Petition Number: Insert Zoning Petition #2022-048

From:	Jake Carpenter, PE	Reviewer:	Patrick Monroe
	Jacob.Carpenter@charlottenc.gov		Patrick.Monroe@Charlottenc.gov
	980-221-5675		704-336-3937

Revision Log:	Date	Description	
	08-25-22	First Review (PDM)

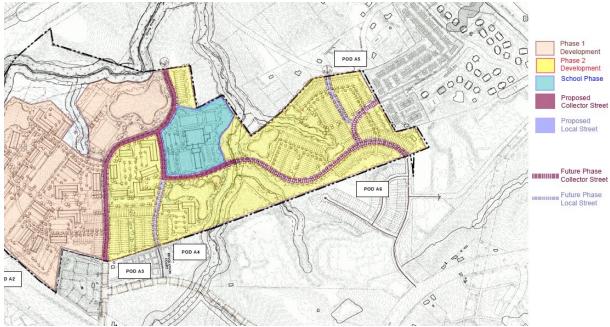
2. Revise site plan and conditional note(s) to commit to improving Galloway Road to the local collector street typical section per U-07.

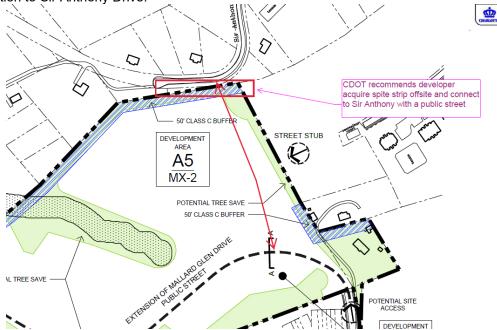
- 02965109, and 02903113
- Revise site plan and conditional note(s) to commit to the proposed roadway network typical sections and proposed phasing outlined in the Traffic Impact Study. Provide typical sections per CLDSM for all proposed public and private streets. Provide 8-foot sidewalk and 8-foot planting strip on all public streets.
